64TH St. & Oak Preliminary Drainage Report 3 engineering Job #: 5153 Original Date: April 10, 2020 COS #: 4-PA-2020

PRELIMINARY DRAINAGE REPORT

Stormwater Review by: **Ghassan Aouad** 480-312-7055 Phone: gaouad@scottsdaleaz.gov e-mail: Review Cycle 1 Date 05/22/2020

Preliminary Grading and Drainage Plans

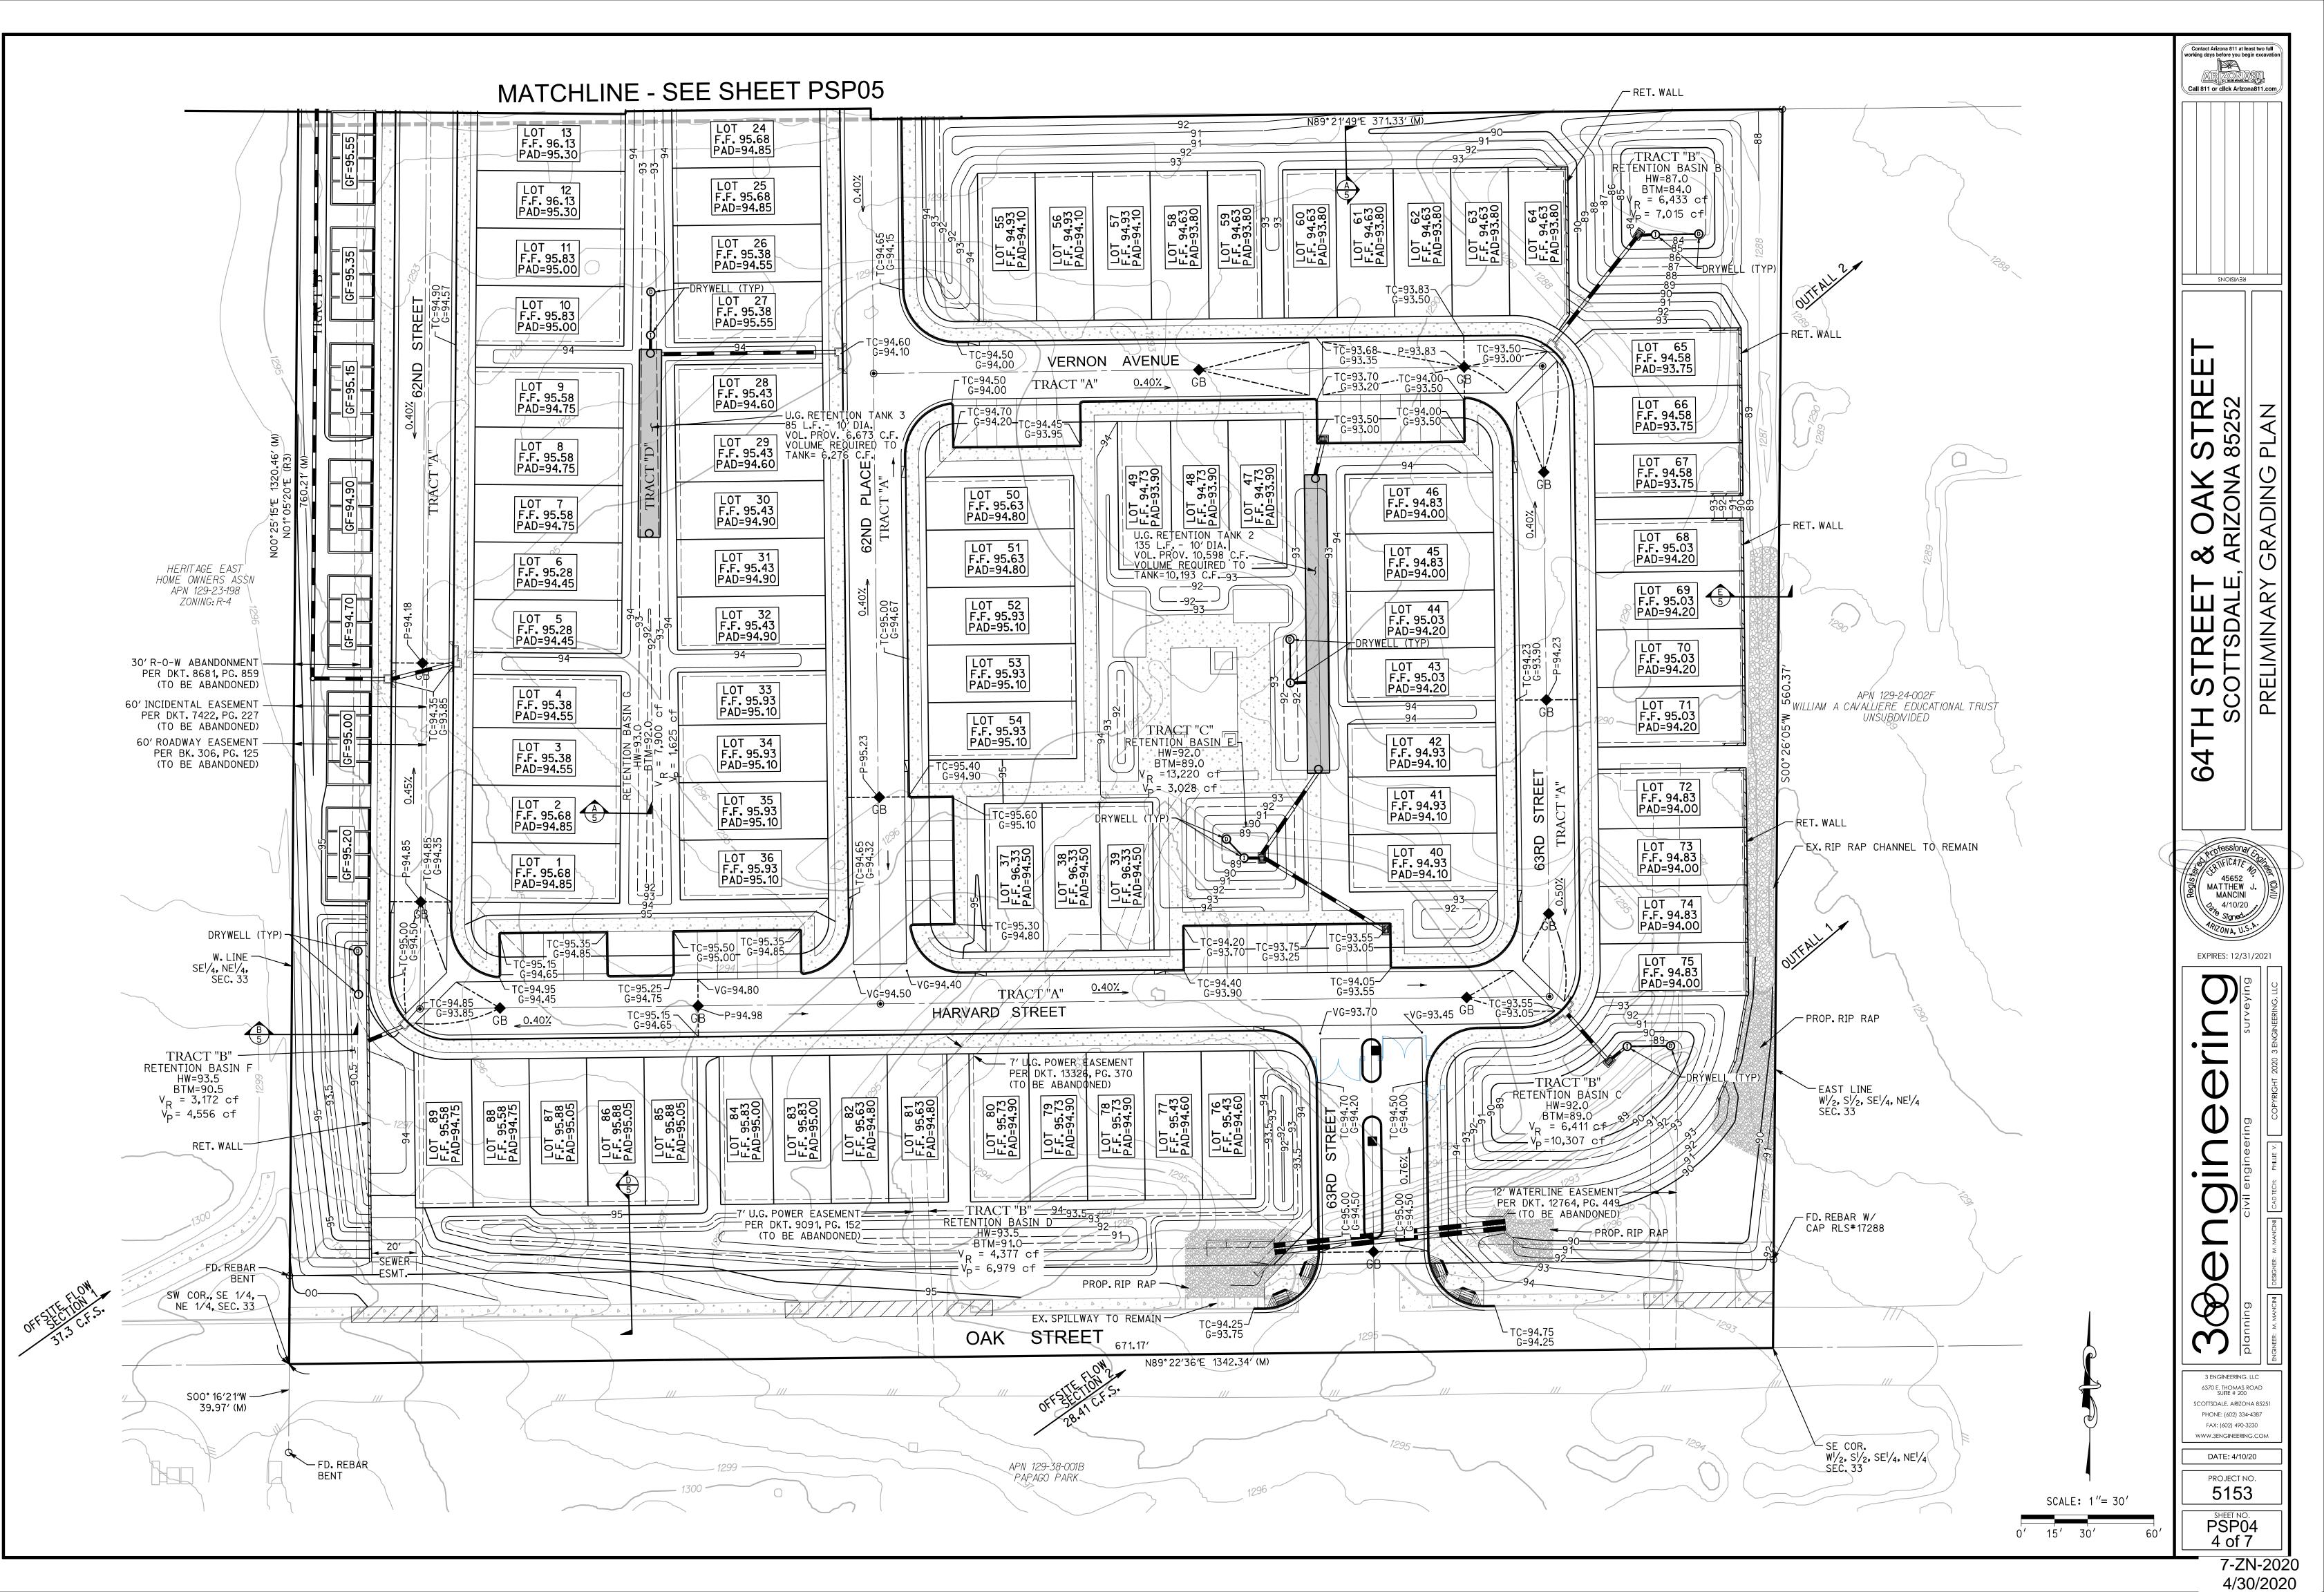
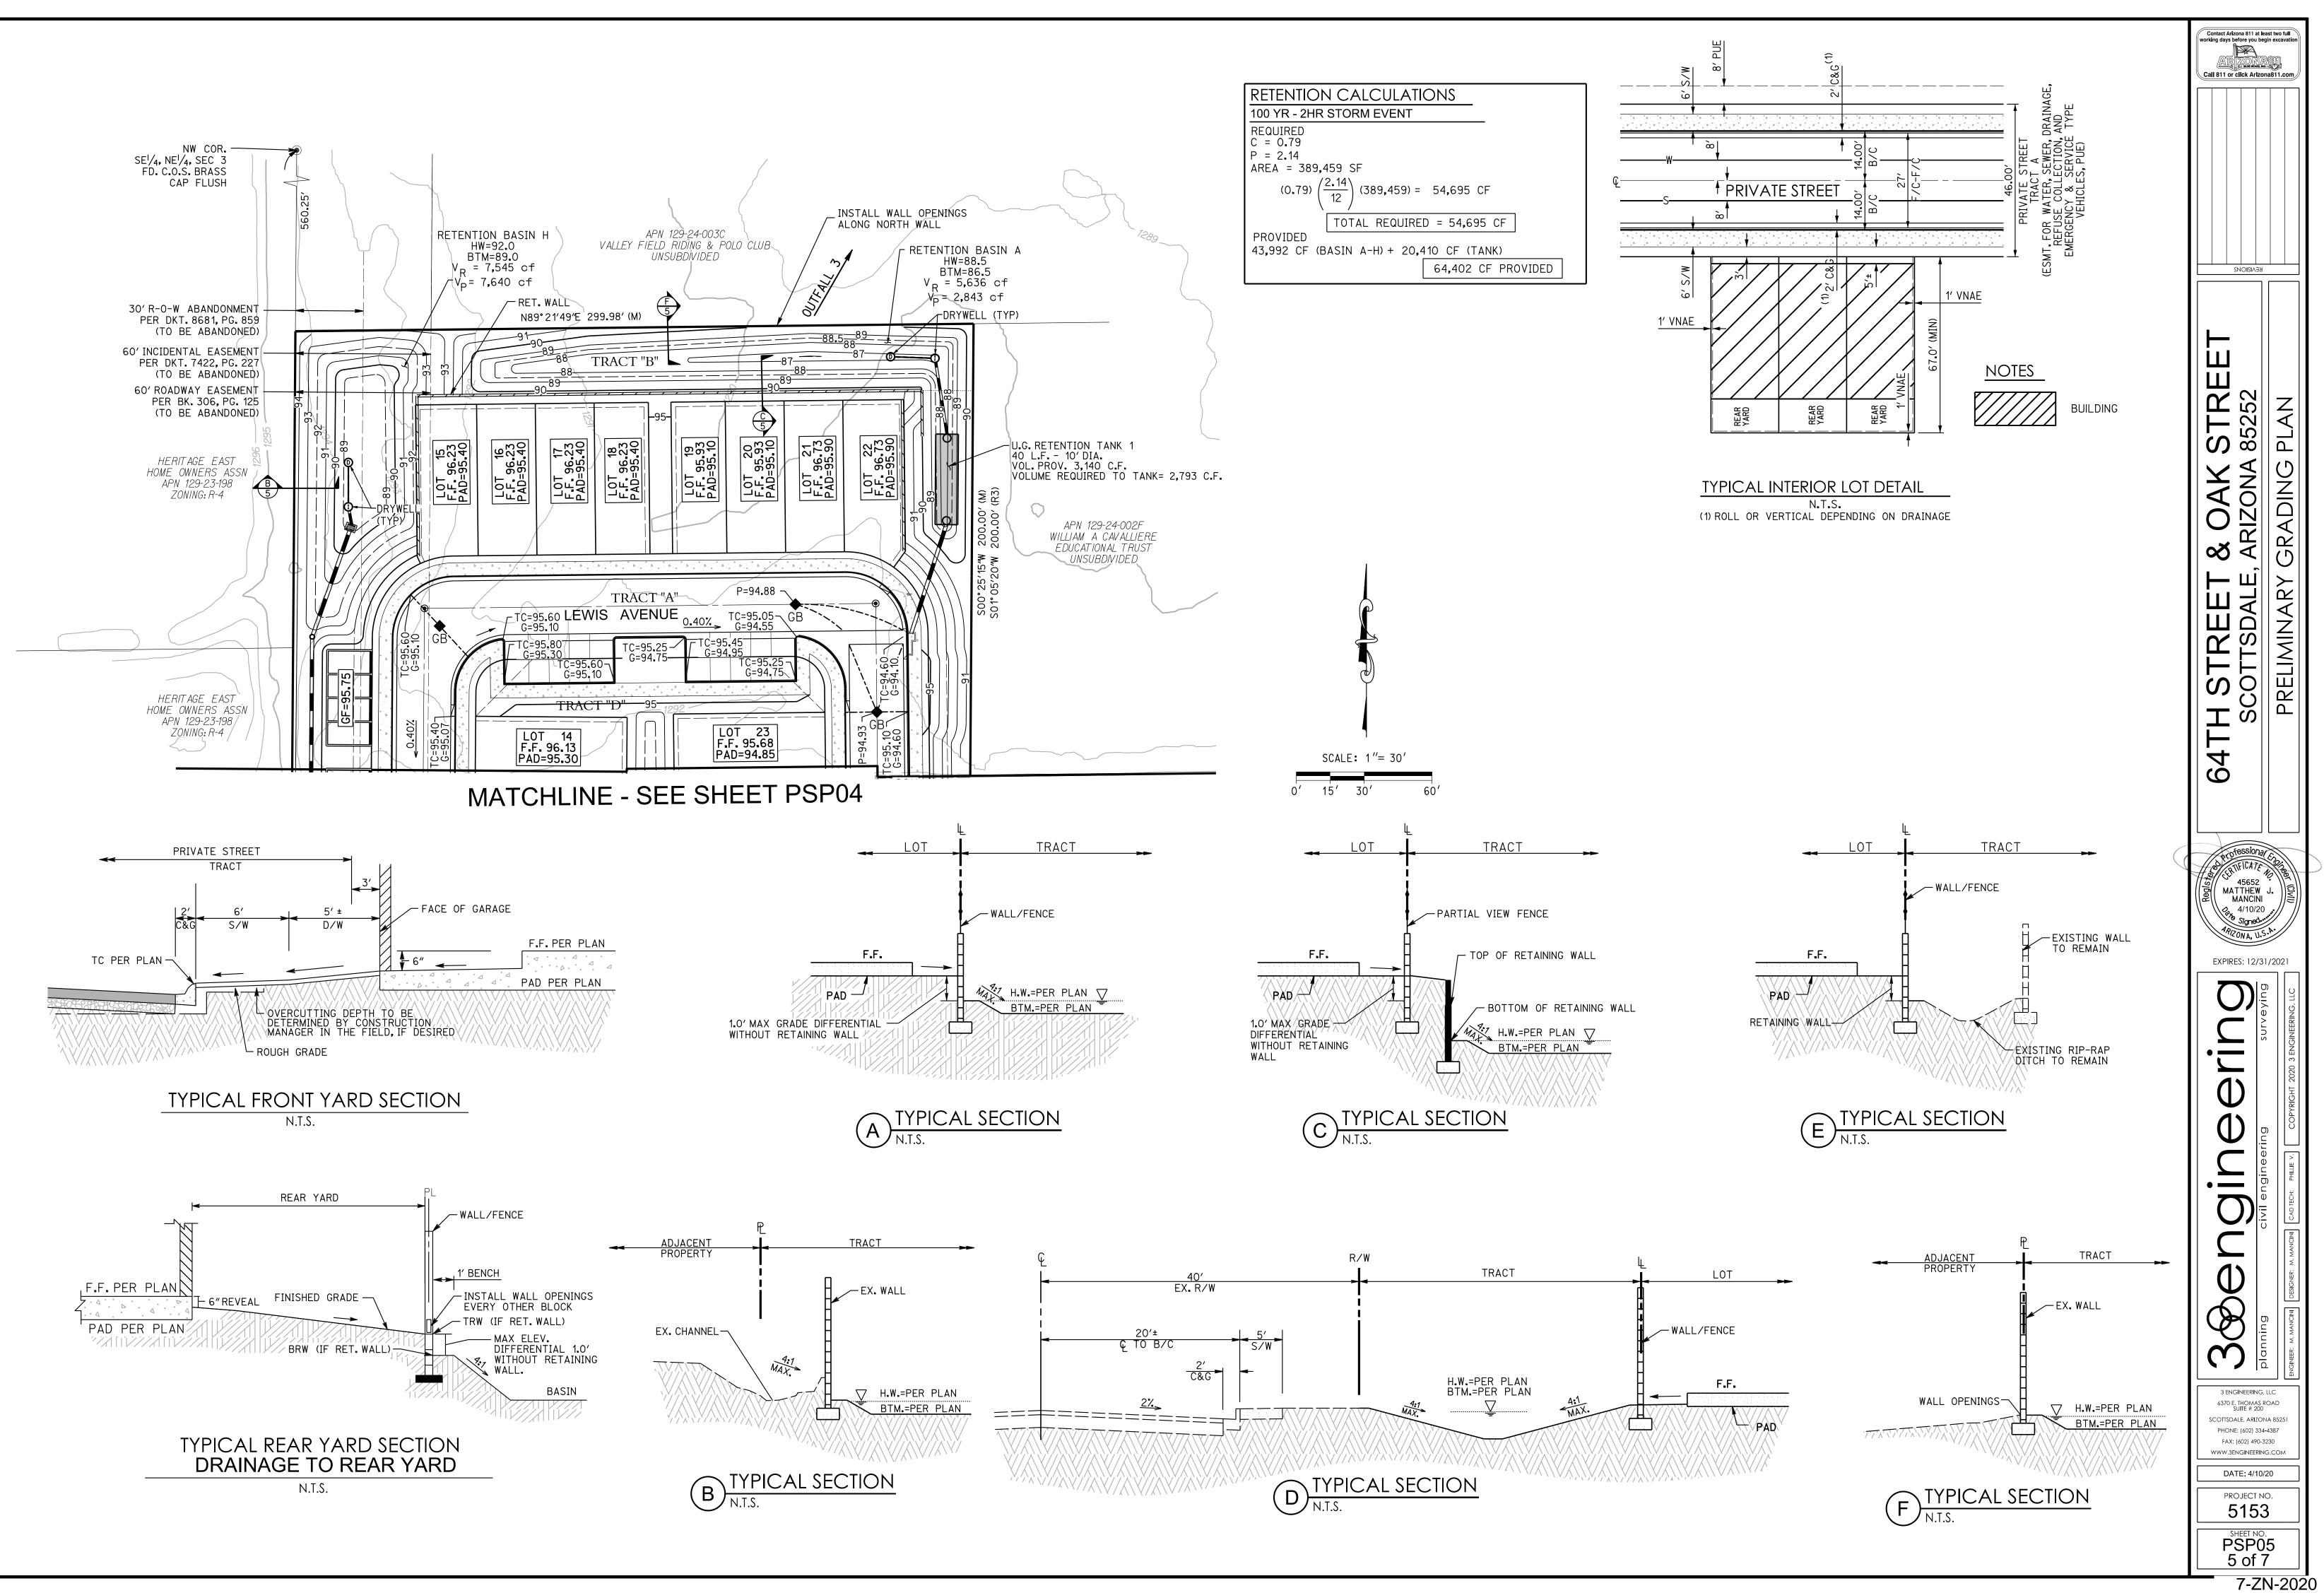
Proposed retentionbasin B at the NE coer is an onsite retention basin. Similar to argument in the comment below, offsite flow can't commingle with onsite flows at an onsite retention basin. The grading around this area need to be revisted to ensure this requirement.

No channel is reflected on the grading and drainage plans?
